ADDENDUM NO. 1

December 5, 2023

ALDER HOUSE RENOVATION
South Bend, Washington

E101

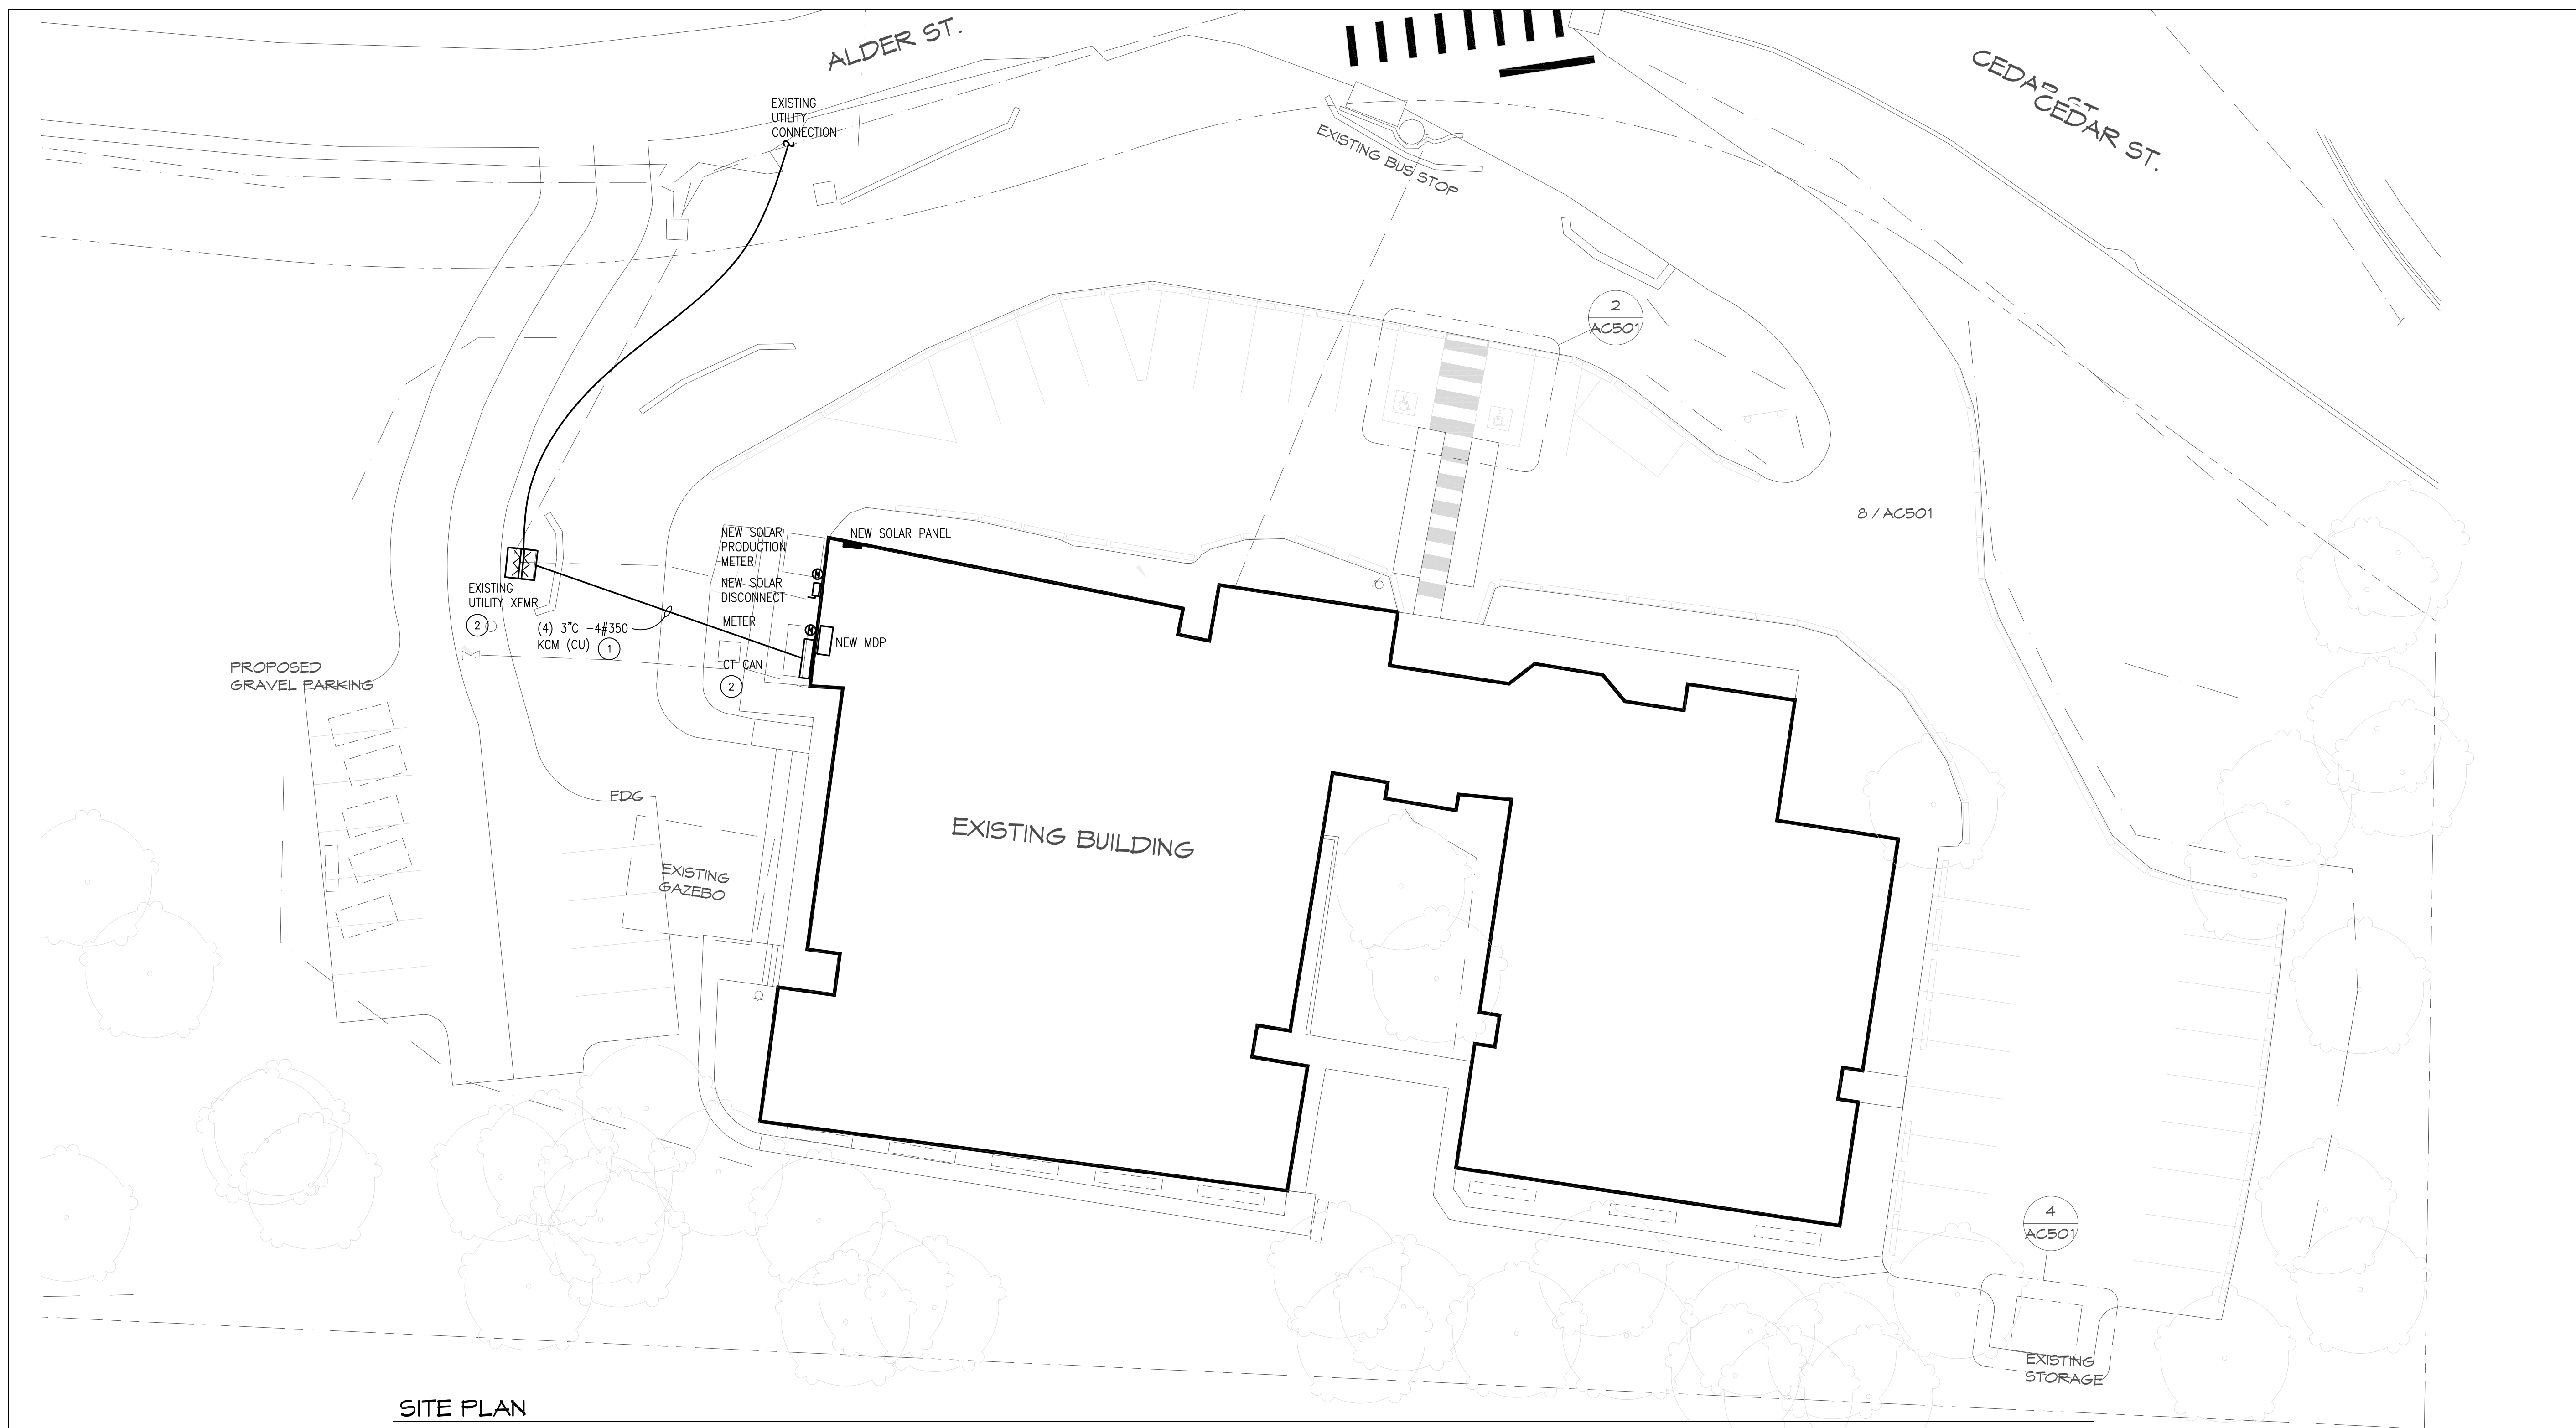
- ① VERIFY EXISTING FEEDERS INTO BUILDING FROM UTILITY TRANSFORMER. ORIGINAL DRAWINGS INDICATE THAT THE EXISTING FEEDERS ARE (4) SETS OF 3\"C-3#350 MCM + #1/0 NEUTRAL. PULL OUT EXISTING FEEDERS AND PROVIDE NEW FEEDERS FOR 1200 AMP SERVICE WITH FULL-SIZE NEUTRAL. (4) SETS OF 3\"C-4 #350KCM (CU).
- ② COORDINATE WITH PACIFIC PUD FOR SERVICE MODIFICATIONS. BASED UPON INCREASED BUILDING LOAD, UTILITY TRANSFORMER, CT CAN AND METER MAY NEED TO BE REPLACED. UTILITY FEES TO BE PAID BY THE OWNER, AND EXCLUDED FROM THE BID.
